© TAIT ELECTRONICS		A2
TM8200		
PCB MFX HEAD REMOTE		
IPN: 220-01721-04	ISSUE: A	VARIANT NUMBER: ?
FILE DATE: Mon Jun 20 11:39:28 2005		
ENGINEER: David Slaten	FILE NAME: 220_01721	SHEET NUMBER: 1 OF 1

TAIT ELECTRONICS	IPN:	ISS:	DATE:	SCALE:
	220-01721-04	A	28Jun05	NTS
TM8200 Head Remote LAYOUT-PRIMARY-SIDE

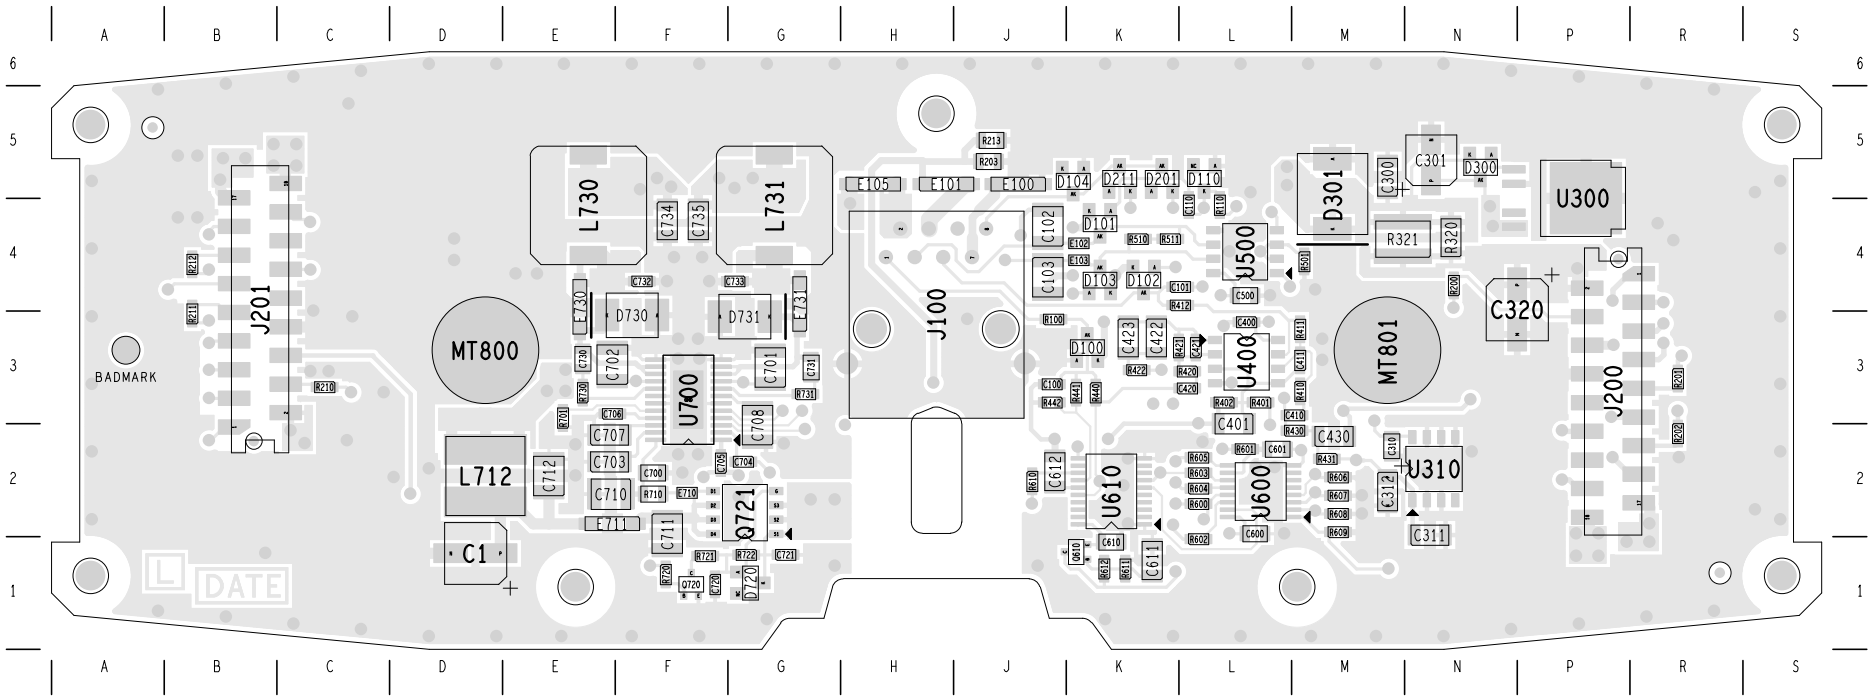
CHANGED C301 TO ELECTROLYTIC
 ISOLATED AGND
 CHANGED BIAS R TO 82K
 C701, C702, C708, C710, C711, C712 TO 35V 2U2

04A	CGND AND AGND SEPERATED	D. SLATEN	SLATEN	CHRIS K	JIMMY Y	16-6-05
REV/ISS	AMENDMENTS	DRAWN	CHKD	D. O.	APVD	DATE
